A. Purple Line Light Rail, Mandatory Referral No. MR2014033

B. Bethesda Metro Station South Entrance, Mandatory Referral No. MR2014034, CIP Project 500929

C. Capital Crescent Trail, Mandatory Referral No. MR2014035, CIP Project 501316

D. Silver Spring Green Trail, Mandatory Referral No. MR2014036, CIP Project 509975

Figure 1-2: Lyttonsville Place Typical Section

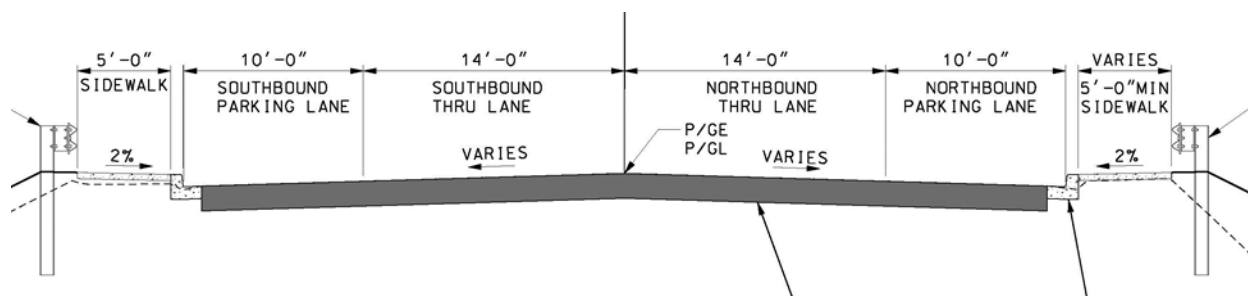
propose 5-foot-wide sidewalks adjacent to the curb on both sides of the road. However, there is approximately 48 feet of space between the curbs, including two 14-foot-wide travel lanes, and two 10-foot-wide outside lanes that are shown below as parking, but have also been referred to as “activity lanes” and would serve as a bus pull-off area and potentially space for on-street parking. MCDOT would like to locate a bus pull-off area just to the south of the bridge, presumably so that buses do not block traffic, even though they have not conducted a study to determine how much the existing intermittent bus service to this area would be increased. Therefore, there is inadequate space for wider sidewalks or bicycle lanes because the space would be set aside for use by buses and parked cars. This issue is discussed in greater detail on page 1-46.

There is a balance to be had for accommodating all of the competing needs around Purple Line station, but pedestrian and bicycle access does not appear to be given much weight, even though that will be the primary mode of access at most stations.

The four transportation agencies need to place a greater priority on station access. Therefore, MCDOT, SHA, and MTA should:

Figure 1-3: Recommended Location of Native Tree Plantings behind the Montgomery County Bus Depot

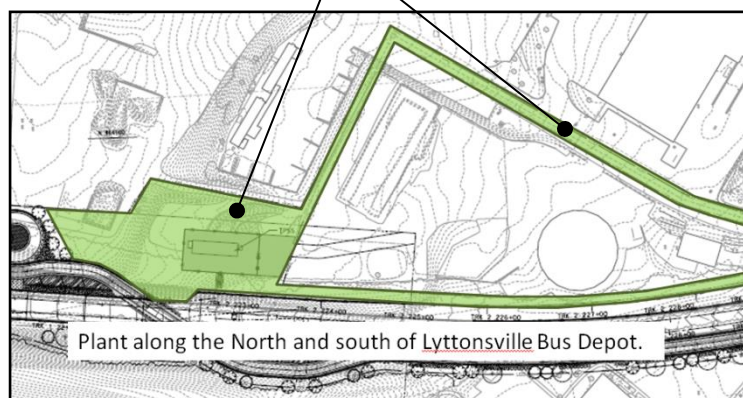
Of particular concern is the lack of tree plantings along many portions of University Boulevard. The community in this area is extremely dependent on mass transit and will likely be frequent users of the Purple Line. As presently shown on the landscape plans, there will be little to no shade cover in the vicinities identified below yet there appears to be more room in the right-of-way than many other areas of the Purple Line where trees will be planted. It is important that the public have a pleasant experience, shaded sidewalks and stations similar to other areas. Therefore MTA must:

- *Provide uniform tree planting spacing (35'-40' on center) and additional native canopy tree cover in the following areas within the Limits of Disturbance, where feasible:*

Figure 1-6: Locations of Traction Power Substations

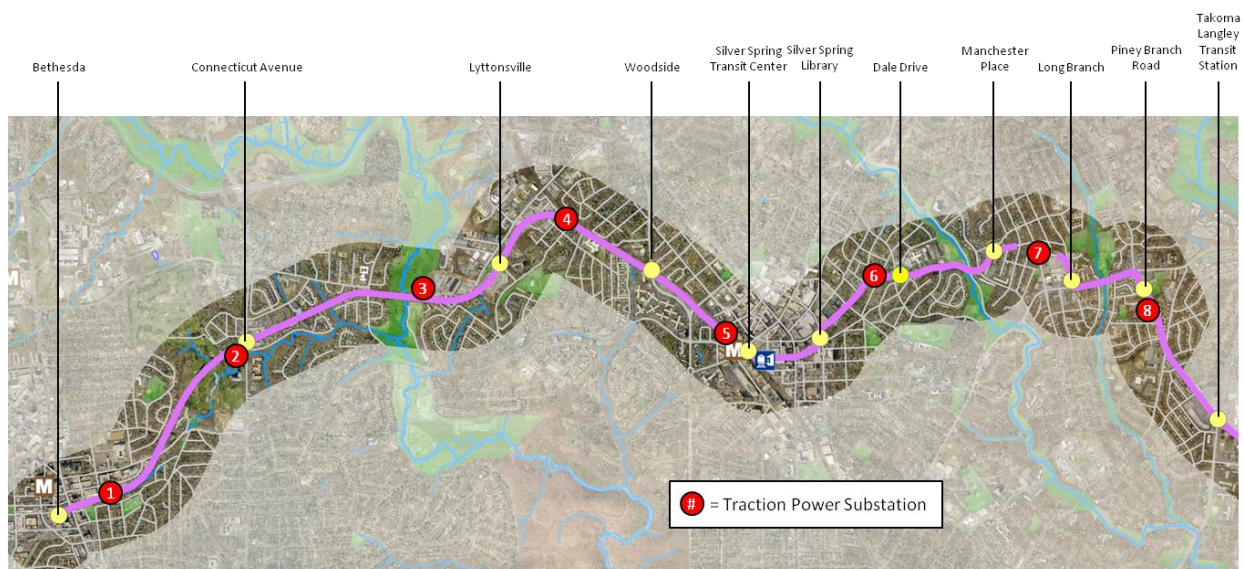
Traction Power Substations (TPSS) convert electric power from the local energy provider to an appropriate voltage for use by the Purple Line. There are 8 substations in Montgomery County spaced about one mile apart (see Figure 1-6). The substations are generally 52 feet by 14 feet, except in Bethesda, where the end-of-the-line substation will be 55 feet by 21 feet. Some substations are located in highly visible locations. MTA is working with the Wayne Avenue community to design the exterior of the substation as a single-family house. This substation is proposed to be designed to fit in contextually within the surrounding community. Therefore, MTA should:

- ➡ *Design each substation to fit in with the context of the immediately surrounding neighborhood and/or should make every effort to minimize both the visual and noise impacts of the substations. Each substation should be evaluated for undergrounding where feasible, especially in high-visibility areas. Where appropriate, design of structures can mimic local vernacular to minimize visual impact.*

Figure 1-9: Number of Catenary Poles by Segment

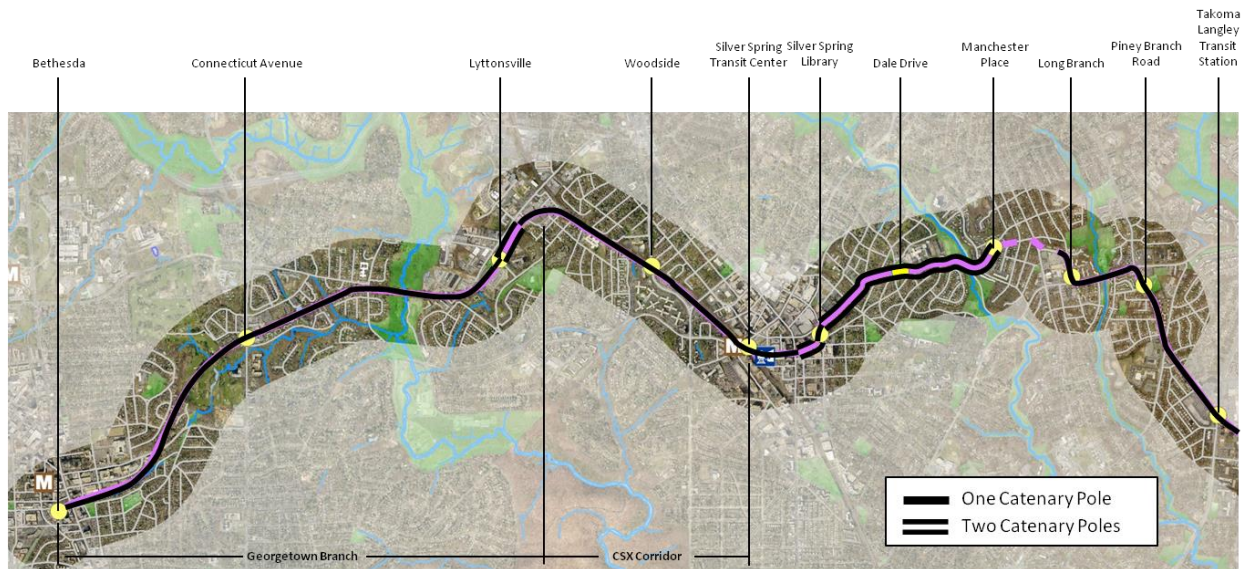
The catenary pole configuration will vary based on whether there is a median between the tracks and whether the Purple Line is in an exclusive transitway. For the Purple Line, there will be one pole in between the tracks in the Georgetown Branch and the CSX corridor and one pole in the median of the road on Arliss Street, Piney Branch Road, and University Boulevard. There will be two poles on either side of the tracks between the west end of the Lyttonsville Station platform and Stewart Lane and two poles on both sides of the road along Bonifant Street east of Georgia Avenue and Wayne Avenue (see Figure 1-9).

- *The catenary system used should minimize the visual impact. Other ancillary gear such as constant tension weights and electrical transmission cables should be covered or concealed within the pole structure.*

Figure 1-26: Alternative Routes between the Red Line and Purple Line

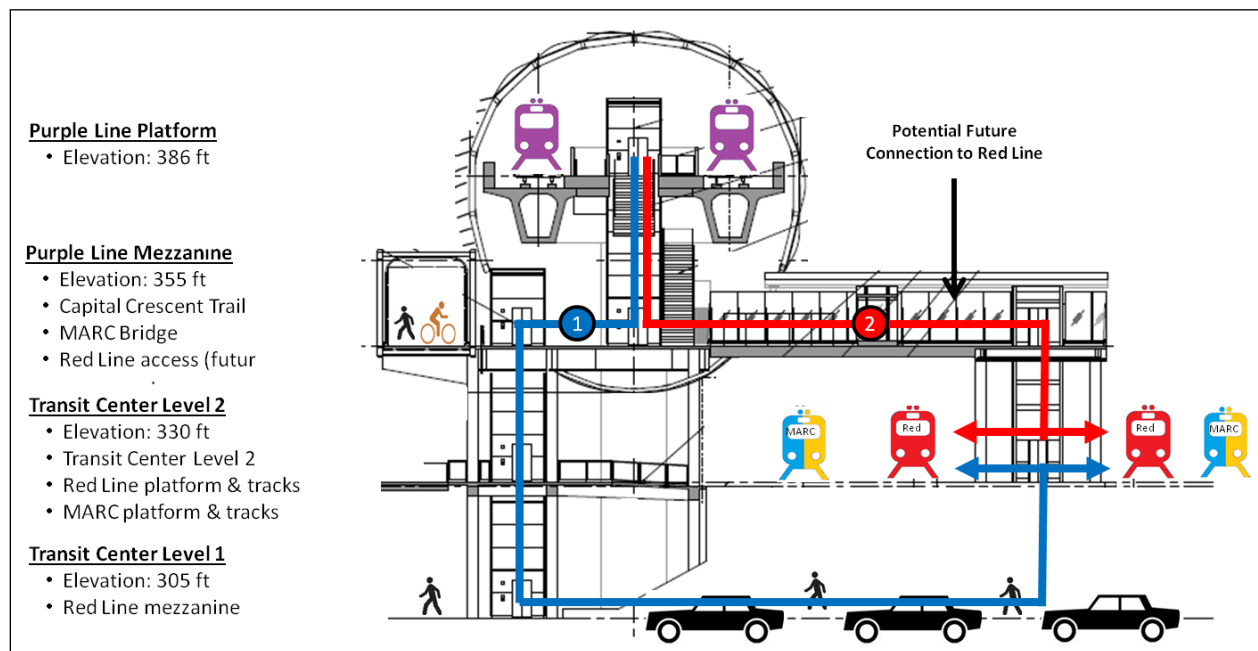
Ease of transfers between transit lines plays an important role in encouraging people to use public transportation. Under existing plans, passengers transferring between the Purple Line and the Red Line will have to descend 80 feet to street level and then ascend about 25 feet to the Red Line tracks (see Path #1 in Figure 1-26). This will increase travel time for passengers and create additional pedestrian congestion in the vertical circulation for the Red Line and Purple Line. With the future direct connection passengers will avoid using the vertical circulation column between the Red Line and the Purple Line (see Path #2 in Figure 1-26). Therefore:

- ➡ *Design and construct a convenient direct connection between the Red Line and the Purple Line at the Silver Spring Transit Center station. (MTA and MCDOT)*

Figure 1-32: Pedestrians Path of Travel at Driveway Ramps

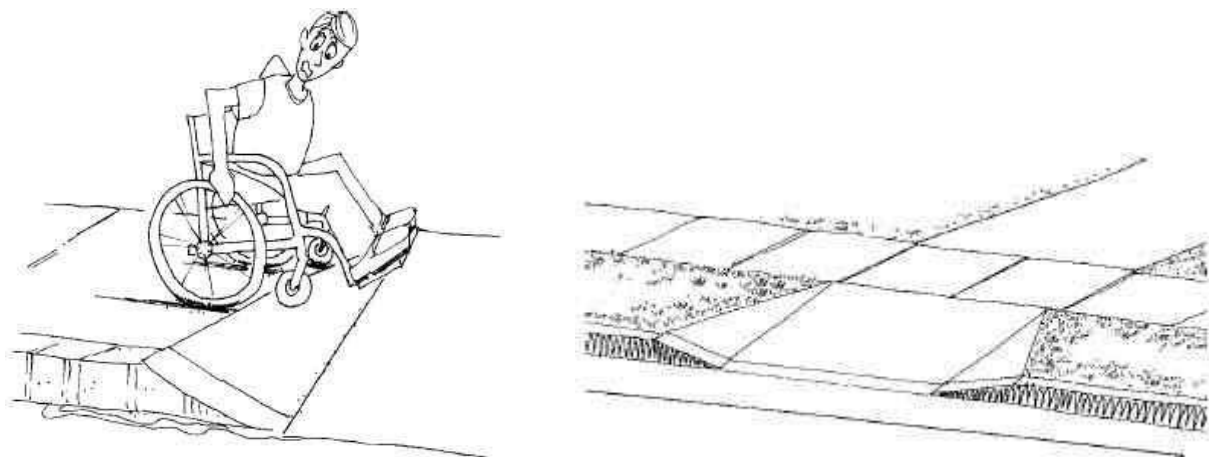
The resulting sidewalk appears to generally meet ADA requirements but does not attempt to meet ADA Best Practices and would be very difficult for a person in a wheelchair to use because it would require negotiating two ramps at each driveway. For example, the south side of the block between Fenton Street and Cedar Street would require negotiating eighteen ramps to traverse one block. Undersized sidewalks that are unfriendly to disabled persons are inadequate to serve rail transit stations. Figure 1-32 shows driveway ramps that interfere (left) and do not interfere (right side) with a pedestrian's path of travel.

- *At the relocated entrance to the school parking lot on Wayne Avenue, offset the trail from the street by building a retaining wall. (MCDOT)*

Figure 3-3: Sidewalk Proposed on Newdale Road

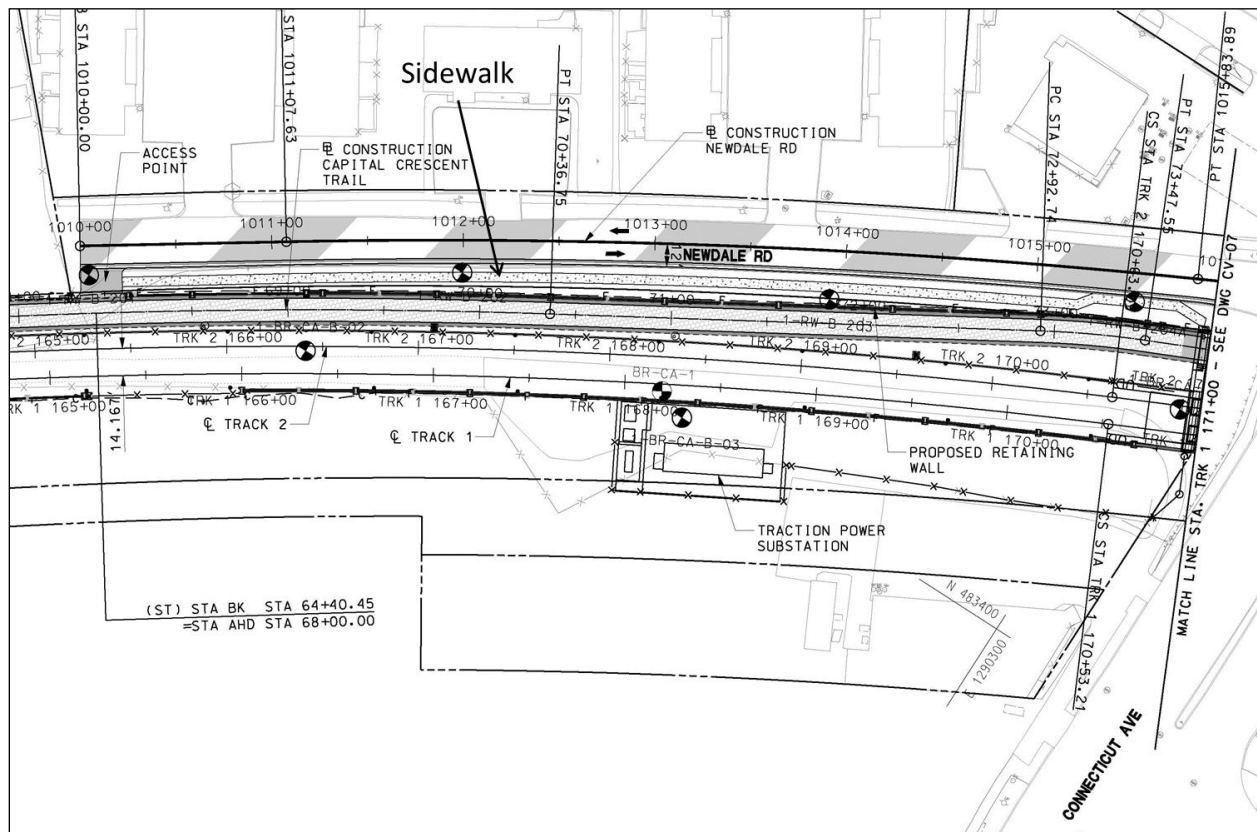
The Chevy Chase Lake Sector Plan recommends a shared use path (LB-4) on the south side of Newdale Road to connect the Capital Crescent Trail to the west side of Connecticut Avenue. Currently, engineering plans show a 5 to 6-foot-wide sidewalk in this location (see Figure 3-3). MTA has indicated that “an 8-foot-wide shared use path cannot be accommodated due to the proximity of MSE Wall 1FO supporting the CCT.” However, it is unclear why the shared use path cannot be widened for most of its length, given that there is a buffer between the path and Newdale Road that is a few feet wide.

- *A shared use path should be provided on the south side of Newdale Road that is 10 feet wide where right-of-way is available, and 8 feet wide in constrained locations.*

Figure 3-10: Capital Crescent Trail Ramp at Lyttonsville Road

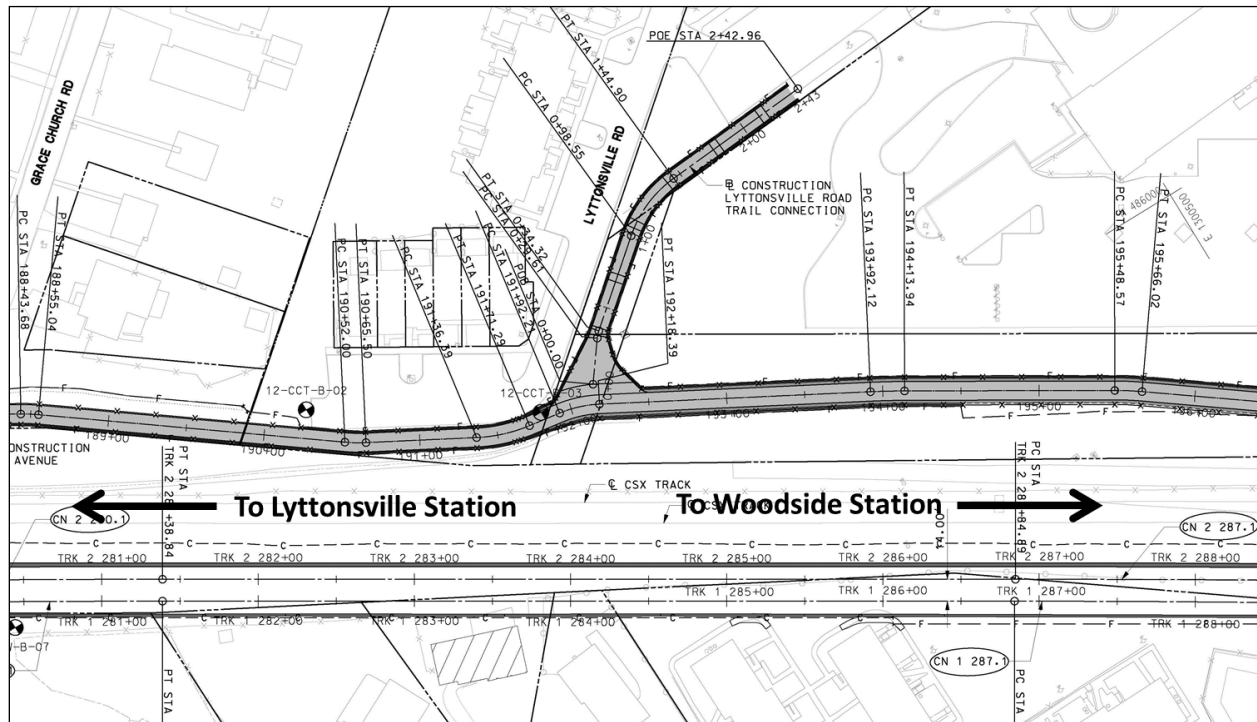
In many locations ramps connecting to the Capital Crescent Trail are not flared. This affects sight distance and makes it more difficult to maneuver between the trail and the ramps. One example is the ramp connecting to Rock Creek Trail. A good example of a flared ramp is at the Lyttonsville access point (Figure 3-10).

- All ramp connections to the Capital Crescent Trail should be flared to the extent possible to facilitate access to the trail.
